FIRE SAFETY INSPECTION REPORT

ANANTA GARMENTS LTD
NISCHINTAPUR,ASHULIA,DEPZ ROAD

March 25, 2014

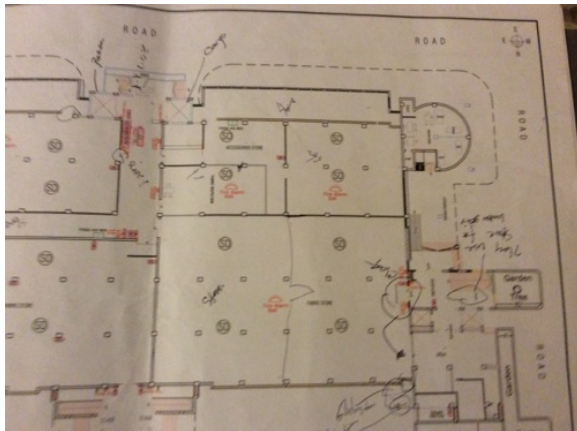
F-9	Egress	Collapsible gates and Sliding doors are provided at building exits, exit stairs, exit discharge. In all floors.	Replace all gates / sliding doors along the means of egress with side-hinged, swinging egress doors.	Within 1 month
			If locks are required for security reasons, utilize special door locking features complying with NFPA 101.

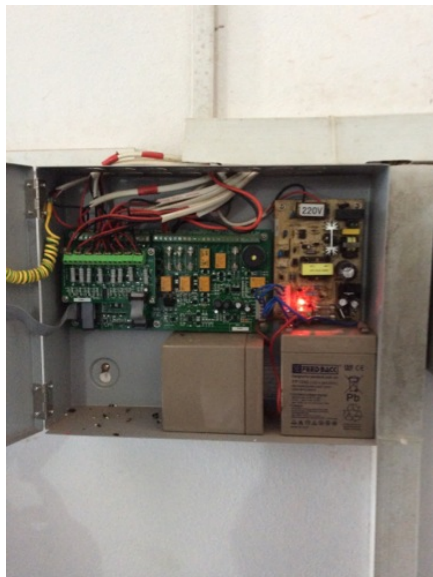
F-13	Fire Protection	The fire alarm system is not an addressable type as reported , and does not provide features consistent with acceptable standards. It is found out that loop wiring for the smoke detector have splices and joints.And also old installed wires were used.	Replace the fire alarm system with a new, listed addressable fire alarm system in accordance with NFPA 72.	Design within 4 months, install within 9 months
------	-----------------	--	--	---

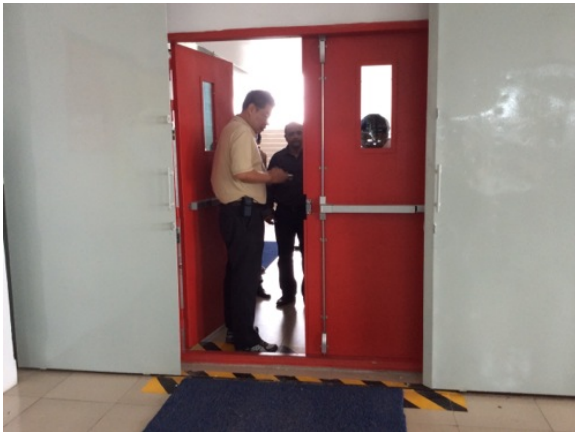
F-18	Fire Protection	Fire doors was provided in exit stairwells but not UL listing is not indicated and automatic door closer is missing , and also door handle is not provided	Provide automatic door closer and shall be tested and inspected in accordance to NFPA-80	Within 6 months
------	-----------------	--	--	-----------------
